## Post-Closure Care Findings and Determination document Comments and Responses

**Figure 3. Figure 24 from Findings and Determination (DTSC, 2006).**

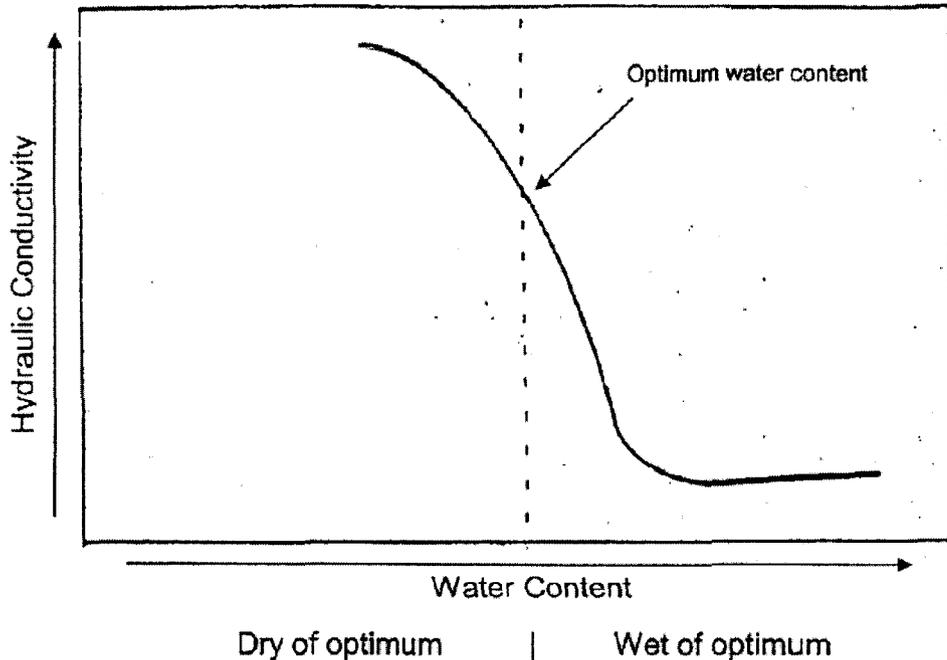
Page 19: Paragraph 3 states, *"The most significant effect of placing the clay layer dry of optimum is that a high leak rate (hydraulic conductivity) will result as shown in Figure 24. This figure shows hydraulic conductivity on the y-axis and clay layer's water content on the x-axis. The optimum water content, which is determined through laboratory testing, is shown as the vertical dashed line in the middle of the graph. As can be seen in the figure, if the water content is less than optimum (dry of optimum in Figure 24), the result is the higher hydraulic conductivity or a greater leakage rate."*

*"The most significant effect of placing the clay layer dry of optimum is that a high leak rate (hydraulic conductivity) will result as shown in Figure 24."*

**5.4.3 Generalization Regarding Hydraulic Conductivity.** While the relationship is true in a general sense, that specific figure (see Figure 3, below) is qualitative in nature and is not based on laboratory testing.

Please see DTSC Response to Comment 74).

Figure 4. Hydraulic Conductivity vs. Moisture Content – Bakersfield Clay Soil

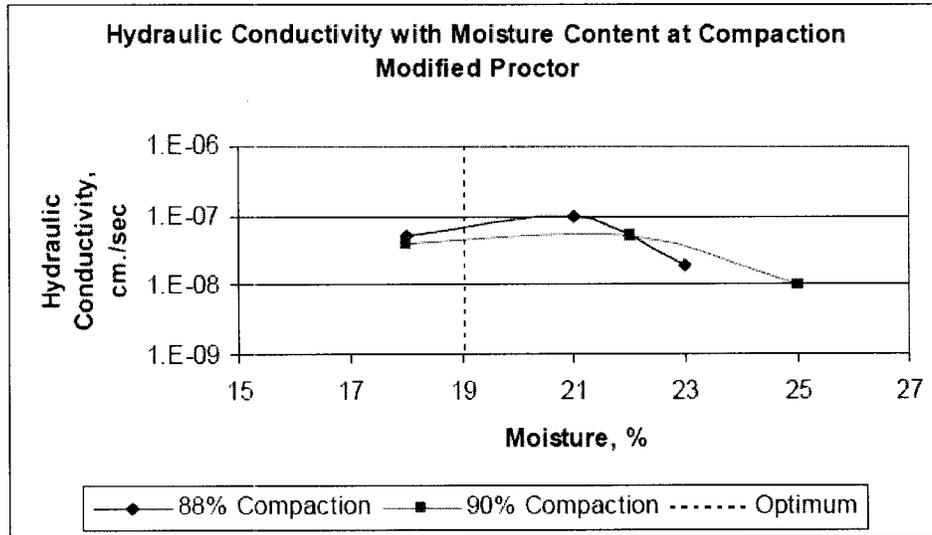
**5.4.4 Liner Compatibility.** A liner compatibility study (EMCON, 1983) on clay liner soil obtained from the Bakersfield Facility determined the hydraulic conductivity at two relative compactions, dry and wet of optimum moisture content. Optimum moisture content was determined by ASTM International (ASTM) D1557 (Modified Proctor). These results are presented in Figure 4, below. As can be seen, for the specific soil used at the Bakersfield site, the variation in hydraulic conductivity is not as extreme as shown in Figure 3, which was derived from USEPA (1991b).

Figure 5. Field Hydraulic Conductivity vs. Moisture Content

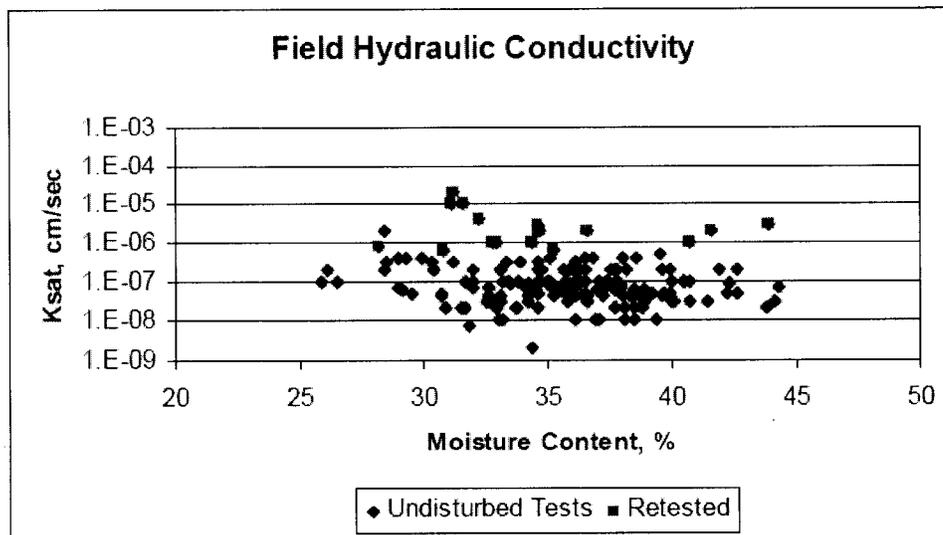
Figure 5 (below) presents all of the hydraulic conductivity testing performed on undisturbed samples obtained during closure construction of the cover.

As can be seen in this figure, there is no indication of increased hydraulic conductivity with decreasing moisture content. Note that all failing field hydraulic conductivity areas were re-tested with passing results as discussed below. A letter dated April 13, 1978 from Mr. Michael Dukes, EMCON Associates to Mr. James Allen, State of California Department of Health Services, Toxic Substances Control, and was accepted by issuance of the permit (DHS, 1991), changed the maximum hydraulic conductivity specification from  $1 \times 10^{-7}$  centimeters per second (cm/sec) to  $5 \times 10^{-7}$  cm/sec.

**Figure 6. Modified vs. Standard Proctor**

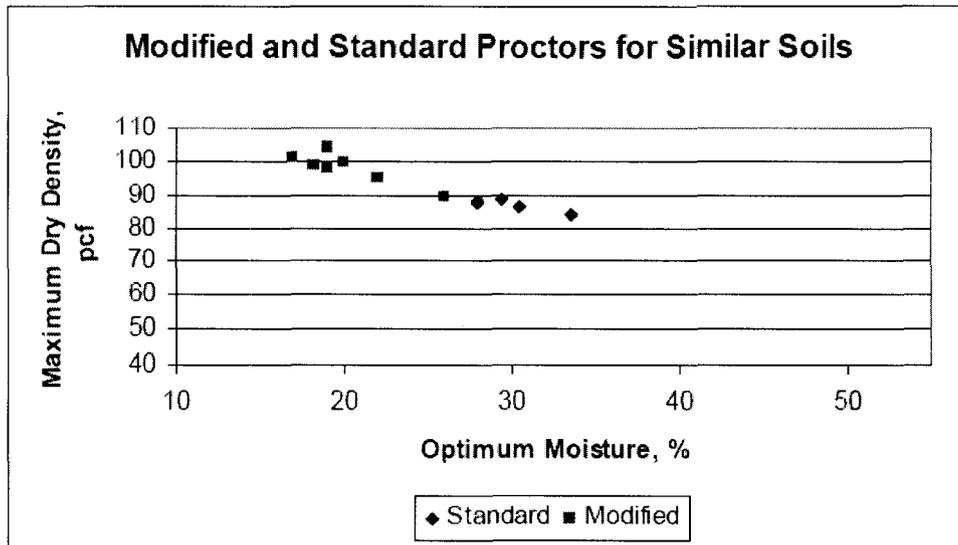
**Liner Material.** At the Bakersfield site, the clay soils used during construction of the base clay liner for the ponds and pits, and the clay soils used during construction of the closure cover, were obtained from the same formation present at the site, the Round Mountain Silt. Therefore, material properties are the same for soils used for both phases of the project. This is verified by review of as-built documentation. During construction of the base liner of the ponds in the EWMU and during the liner compatibility study, optimum moisture content was determined by the Modified Proctor. Laboratory optimum moisture as determined by the Modified Proctor during base liner construction and as determined by the Standard Proctor during closure cover construction were compared for soils with similar Atterberg limits (plasticity) and percent minus the No. 200 sieve (Figure 6) and indicates that all Standard proctor optimums are greater than Modified optimums for similar soils. Therefore, the clay material at a moisture content 3 percent over Modified optimum moisture is 3 to 9 percent less than Standard proctor optimum moisture.

Additionally, the USEPA (1991b, page 14) indicates that moisture contents at compaction one percent over optimum moisture content Standard Proctor, are sufficient to mold clods together and achieve the desired soil structure.

Please see DTSC Response to Comment 74).

Figure 7. Standard Proctors Performed During Closure Cover Construction

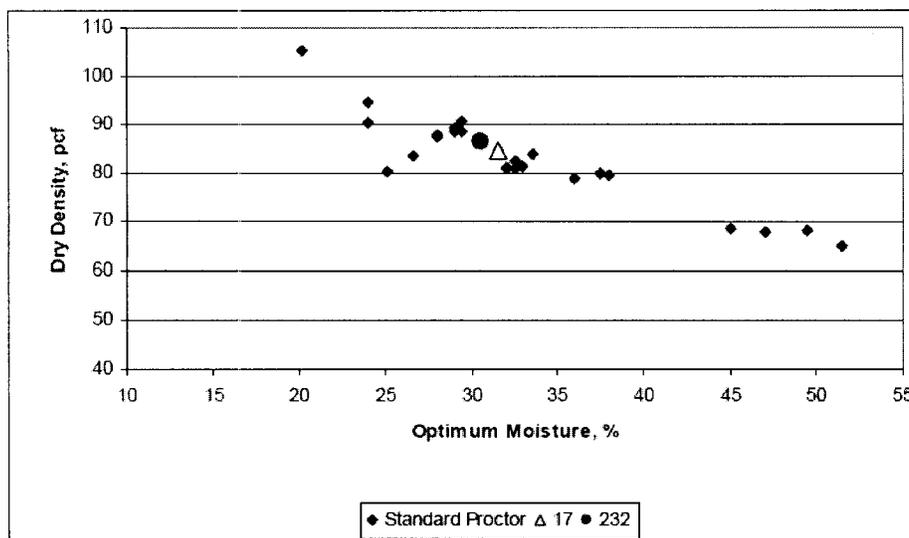
**5.4.7 Moisture Analyses.** As previously discussed in our comment to Page 19: Paragraph 2, Item 1, optimum moisture content is determined by laboratory testing. During construction of the cover’s clay layer, 26 Standard Proctor tests were performed in the laboratory. However, only two of these Standard Proctors (Nos. 17 and 232) were used by the field Construction Quality Assurance (CQA) personnel when evaluating nearly all of the field density and moisture content results

Figure 7 presents the maximum dry density and optimum moisture content for the Standard Proctors performed during construction of the cover. Also indicated on the figure are laboratory test numbers 17 and 232, which are the optimum moisture content results of the two Standard Proctors used to evaluate nearly every field density and moisture content test performed during construction. As can be seen in the figure, there are several optimum moisture content values that are below and above the values used to evaluate the results. Therefore, it appears that correlation of a specific field moisture content with an appropriate optimum moisture determined from laboratory testing on a similar soil was not performed by the field CQA personnel. However, a general relationship between the moisture content at compaction and the optimum moisture content can be made as described below.

Please see DTSC Response to Comment 74).

Figure 8. Line of Optimums

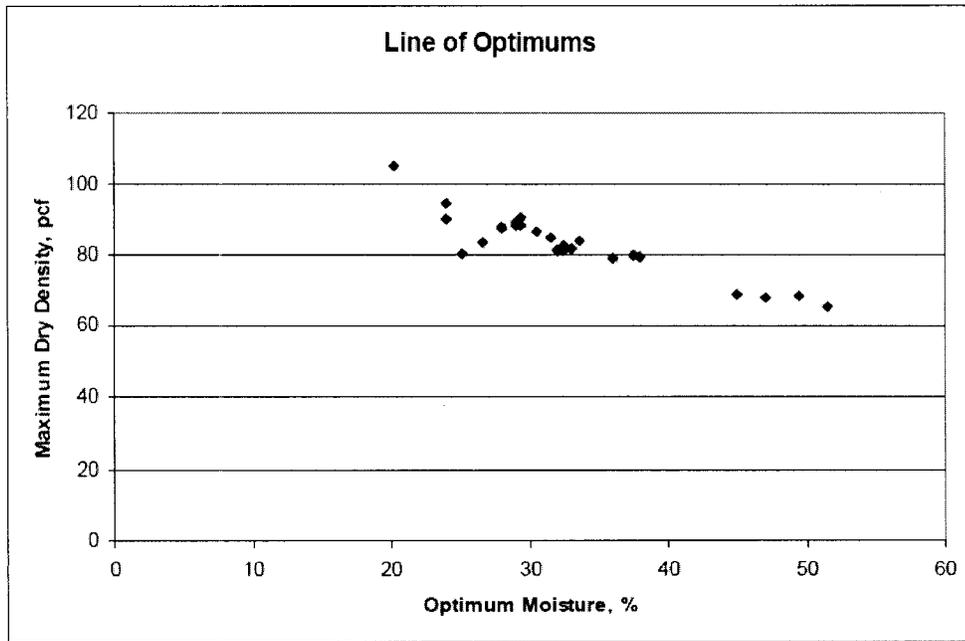
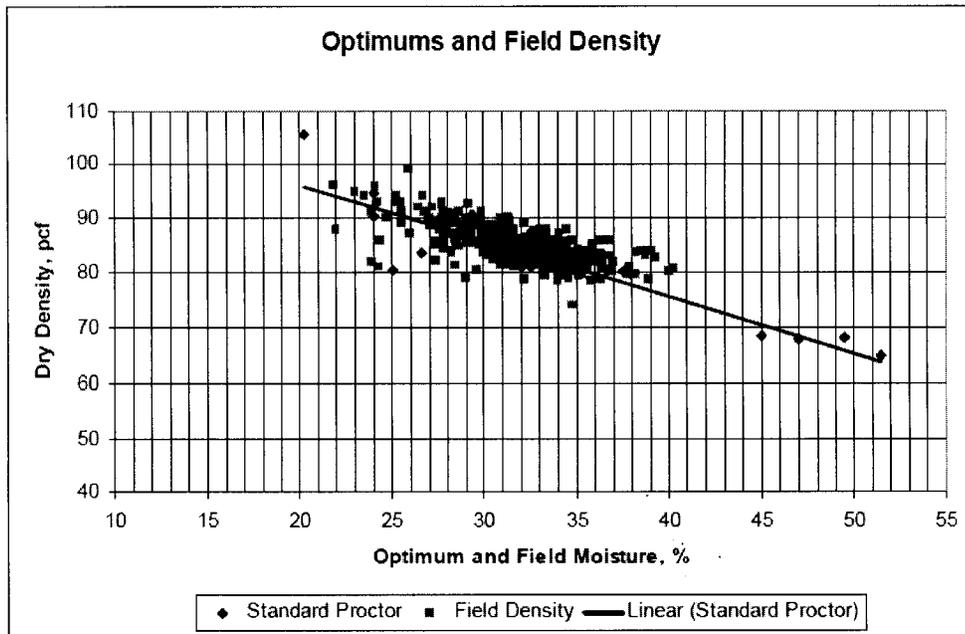
**5.4.8 Maximum Dry Density.** When the maximum dry density and optimum moisture content for all of the Standard Proctors performed during construction are plotted, the “Line-of-Optimums” results (Figure 8). The Line of Optimums is the moisture content that requires the least amount of compactive effort to achieve the maximum density for the soil. When the field density and moisture content test results are plotted with the laboratory tests, it can be seen that the trends are coincident (Figure 9). **What this indicates is that the CQA and construction personnel adjusted the moisture content in the field to be at or very near optimum moisture as determined by the Standard Proctor in accordance with the general recommendations in the USEPA (1991b) document.**

Page 19: Paragraph 2, Item 3. *“Placement of the clay layer was significantly dryer than optimum (-9.6%) which would result in excessive dryness, and cracking of the closure cover.”*

Please see DTSC Response to Comment 74).
